Update on the Thruway's Broadway Projects

March 30, 2018

Memo to Richard Slingerland, Administrator, Village of Tarrytown

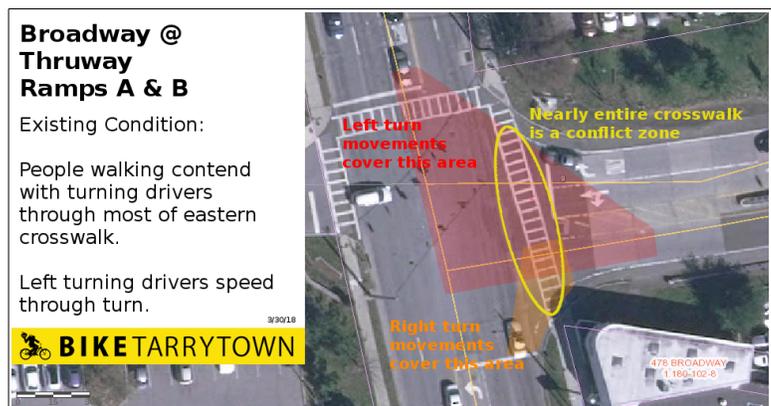
Refuge Between Ramps A & B

Update: State DOT staff object to a pedestrian refuge between the Thruway exit/entrance ramps at the Honda Dealership. The sole "safety" measure planned is setting walk signal times based on crosswalk length and how fast an average person walks.

Issues: Such reliance on distance based timing alone is unsafe. Research by New

York City DOT found people making left turns in their cars are particularly dangerous to people walking:

- Speeds are high
- Angles involved mean cars cover much of the crosswalk, turning them into giant "conflict zones" (see diagram, above)
- Watching for gaps in oncoming traffic requires significant attention by drivers
- Pillars between windshields and driver side windows hamper visibility from drivers' seats

To combat these problems, NYC DOT has deployed tactics including median refuges (see diagram, right) to improve safety. Most importantly, refuges moderate speeds and organize drivers into specific areas of crosswalks. They also provide safe spaces for people who don't walk fast enough to cross the whole street at once. ("[Don't Cut Corners](#)," NYC DOT, August 2016)

The unpleasantness of the existing crossing limits walking from the Pennybridge neighborhood. The Thruway's turn lane project widens the crossing, exacerbating the isolation.

To Do: Apply political pressure on State DOT to ensure a median refuge gets built.
